RIVERVIEW PLANNING ADVISORY COMMITTEE

STAFF REPORT

Subject : Multiple unit dwelling Conditional Use and a landscaping variance

File number: 25-0103

DRAWING TITLE
SCHEMATIC SERVICING & GRADING PLAN

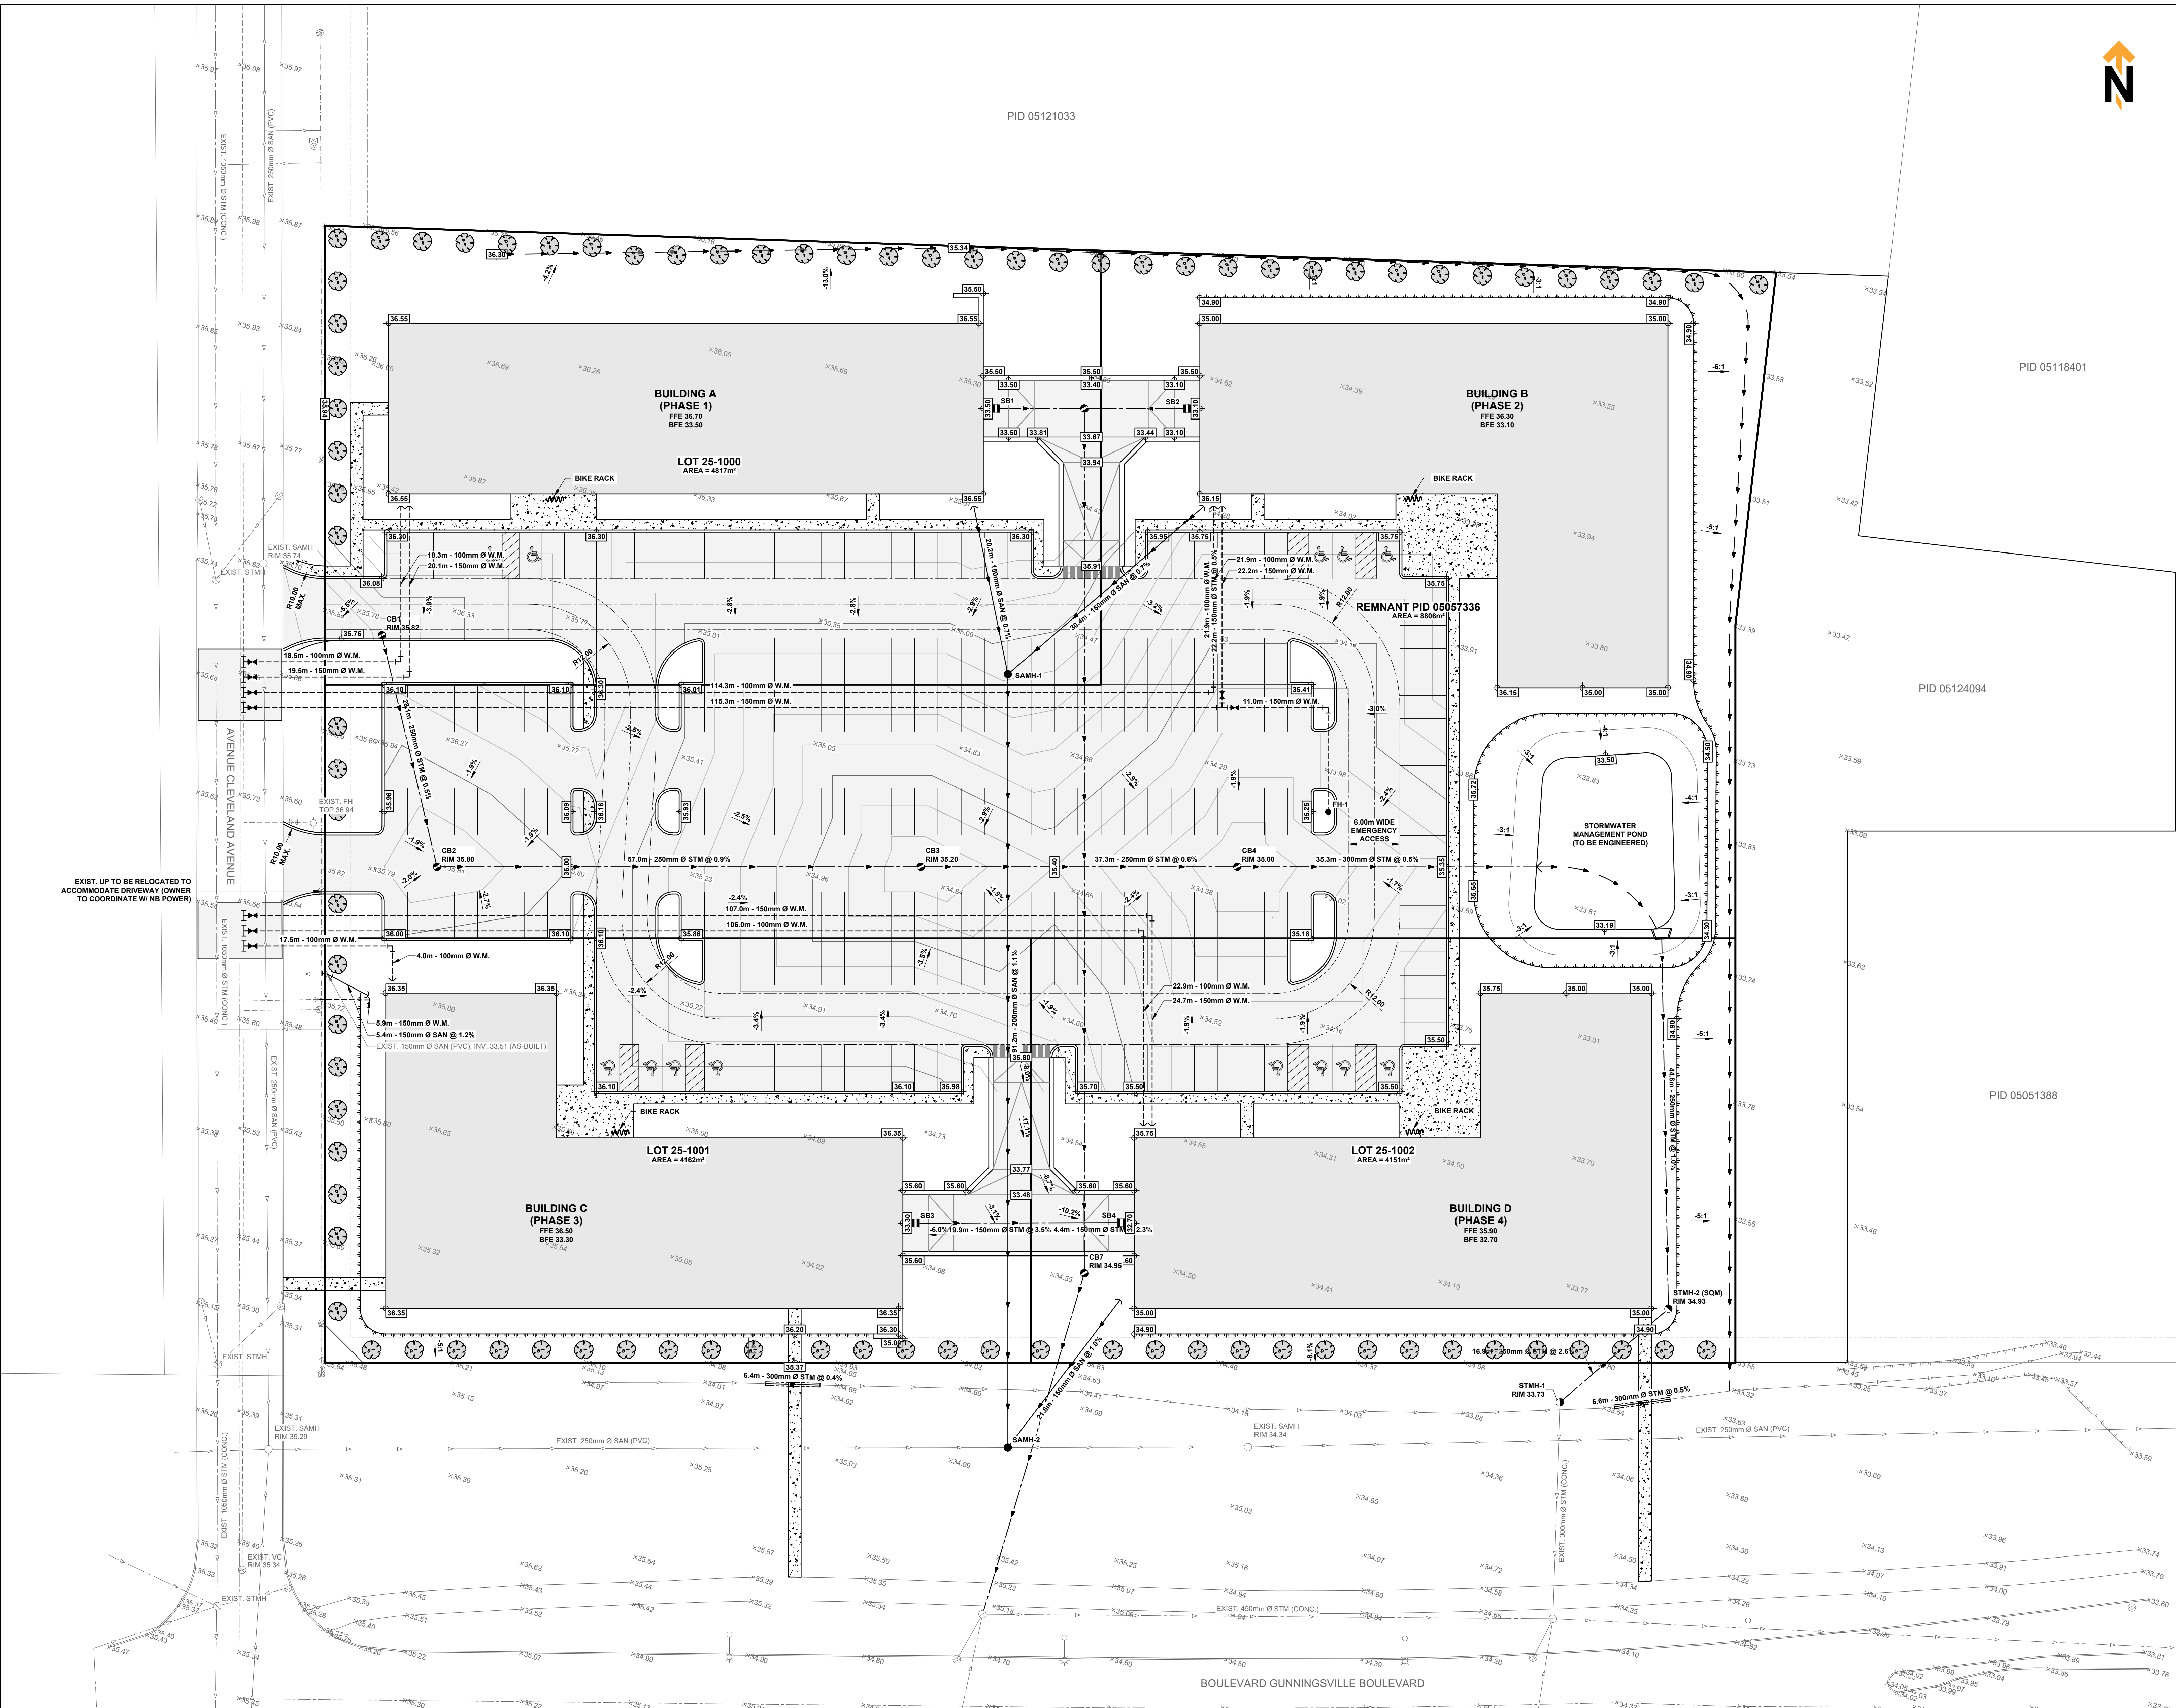
Engineering noted that the stormwater retention pond marked on the site plan will need to be constructed with the first phase of the development (the current proposal before the PAC).

(2) That the construction of the stormwater detention pond proceed with the development of the first phase of the project, and be subject to approval from Town of Riverview Engineering and Public Works Department.

Drawing Title: **SITE PLAN - PHASE 1**

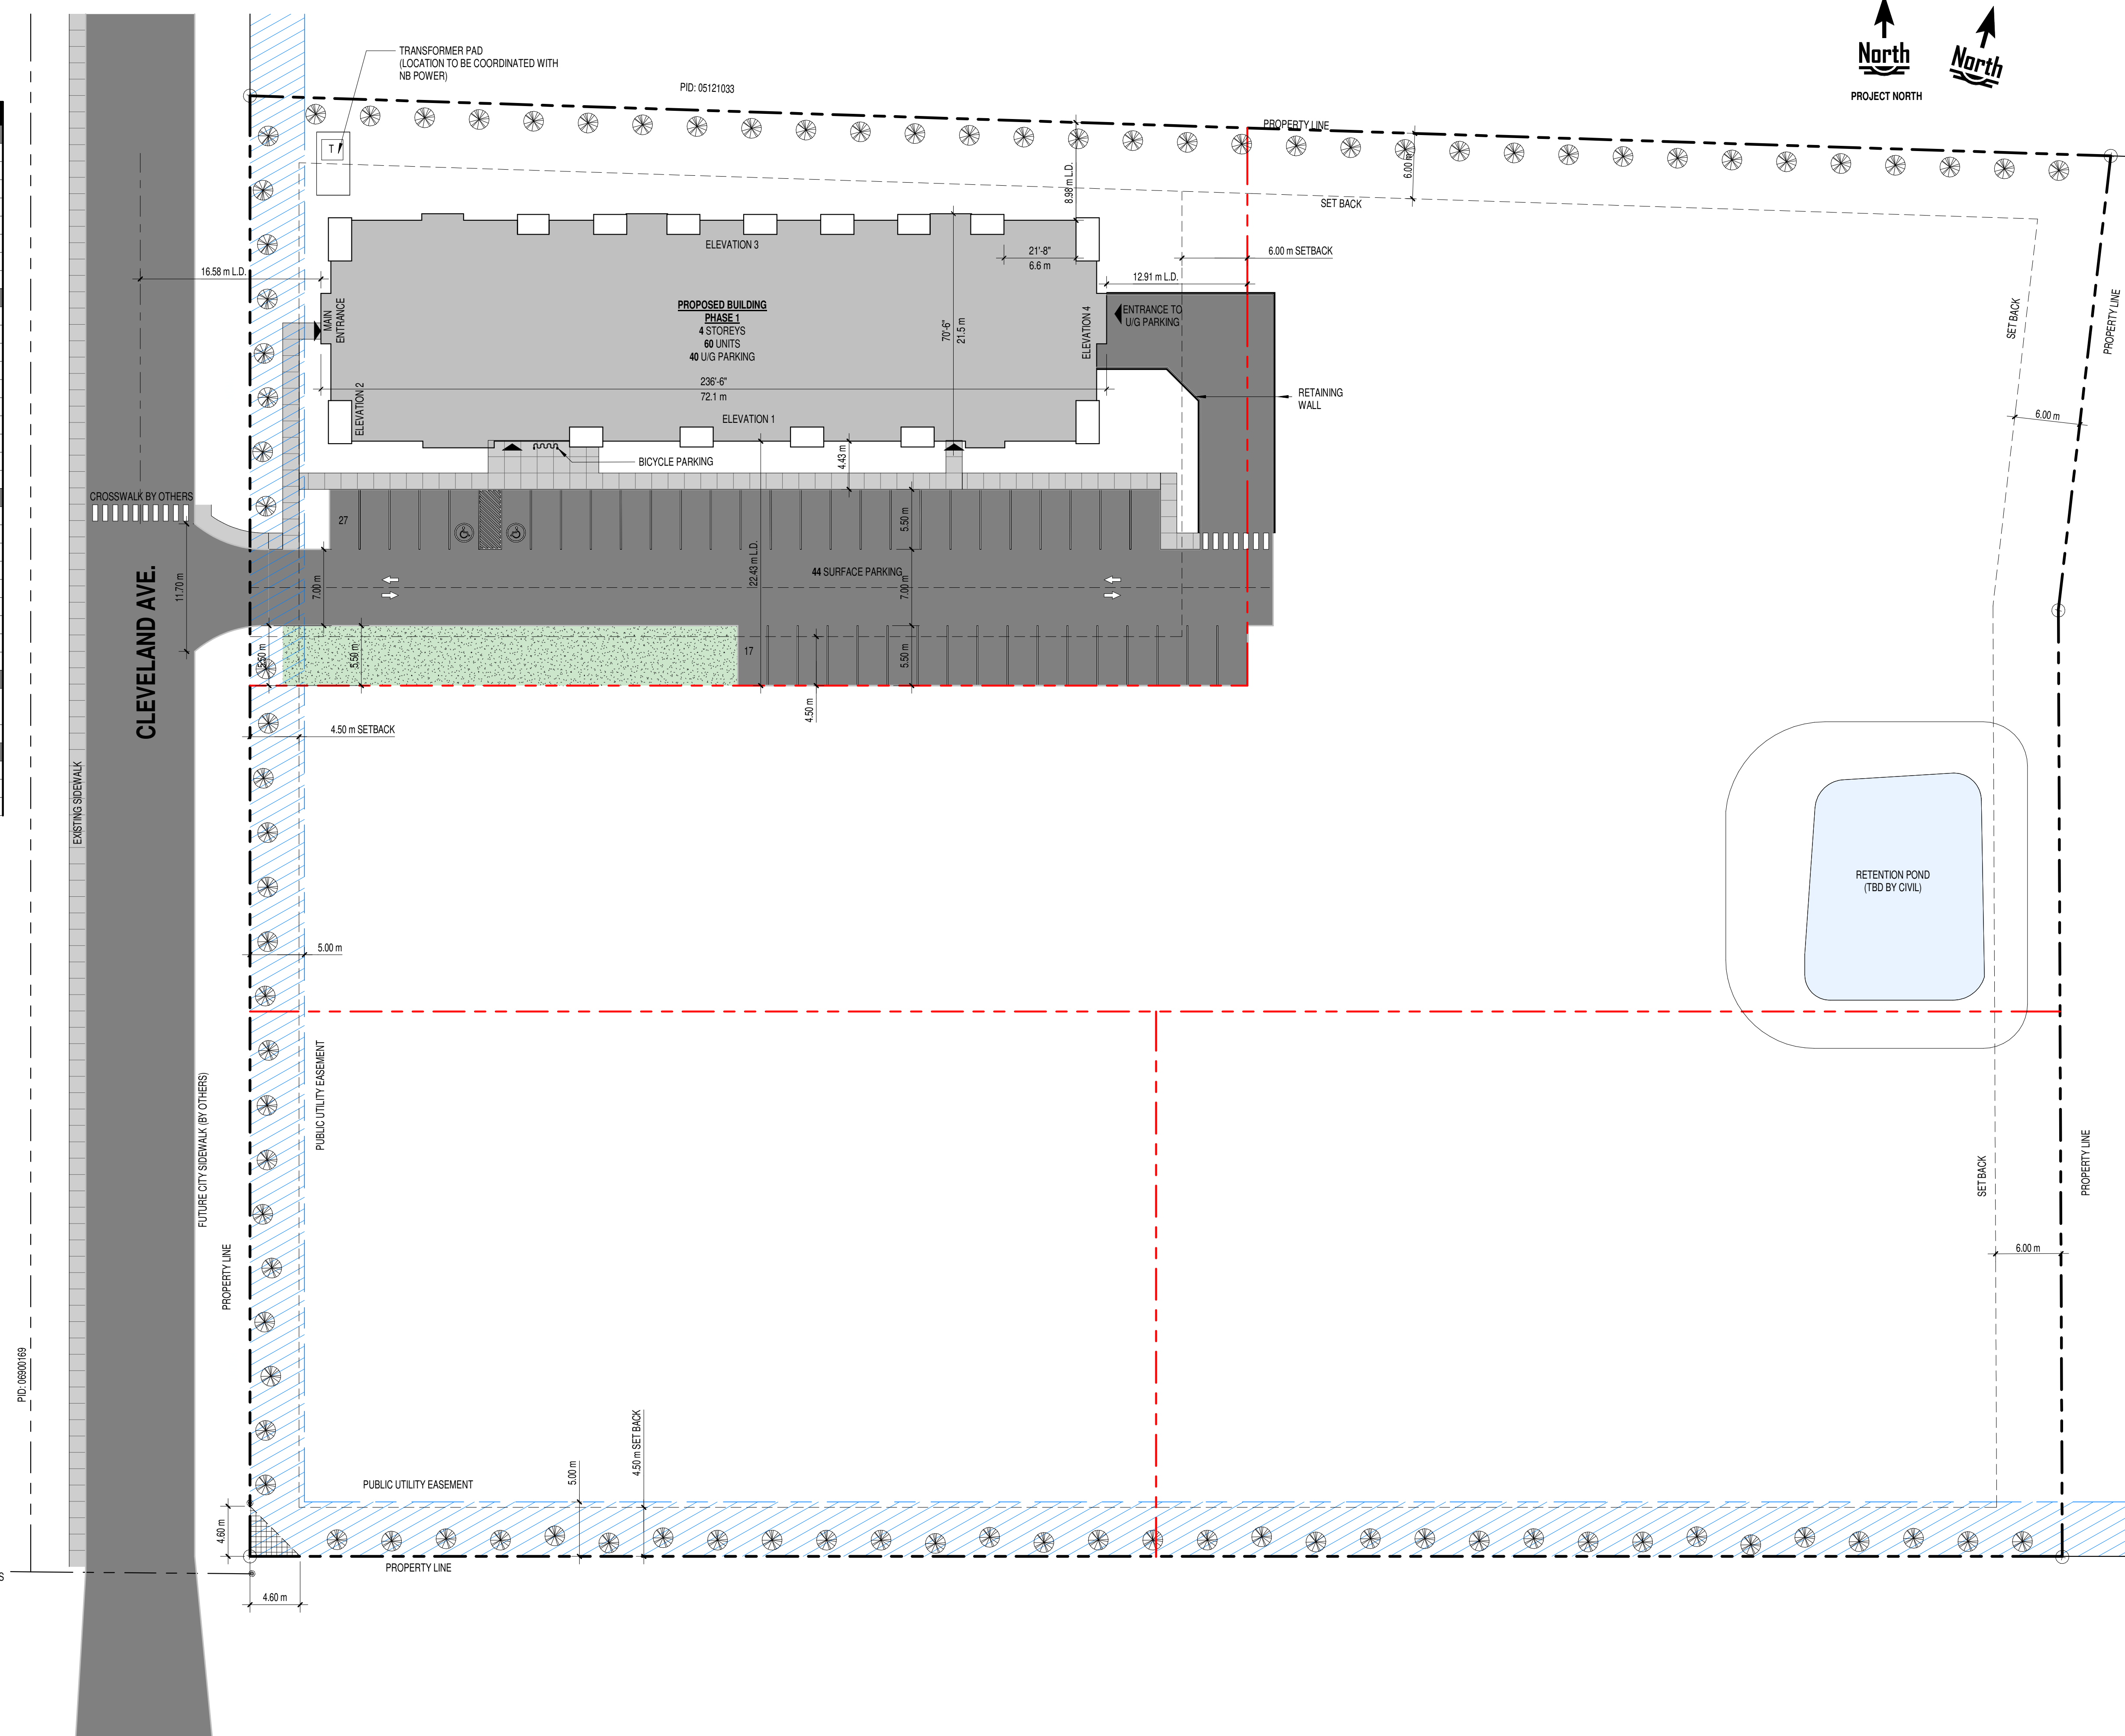
Section 42(4) of the Zoning By-law requires that at least 5% of the internal area of a parking lot is required to be landscaped. While the current proposal is for only the first phase of the development, it is anticipated that a large parking area will be shared between the future buildings on the lot. The site plan for the future phases shows that the internal landscaping area requirements are able to be met. Notably, the landscaping areas on the outer edge of phase 1 parking, will become part of the internal landscaping requirements as the development continues in the future.

With regards to the current proposal, all other landscaping requirements of the by-law are met, including the landscaping along the north boundary of the property to buffer from development on the abutting lot, and a section of landscaping on the exterior of the parking lot. As the intent of the internal parking landscaping requirements is most likely to break up large areas of continuous parking, it will be more important to meet this requirement in future phases of the development occur. The variance is considered to be reasonable, desirable for the development of the land and within the intent of the Municipal Plan as adequate landscape screening is provided and there remains an opportunity to meet internal landscaping requirements of the parking lot with future phases of development.

Item 2 Staff recommend that the Riverview Planning Advisory Committee APPROVE the variance to reduce the required internal landscaping requirement from 5% of the internal parking area to 0% of the internal parking area as the intent of the by-law to break up large, continuous parking areas with landscaping can still be met.
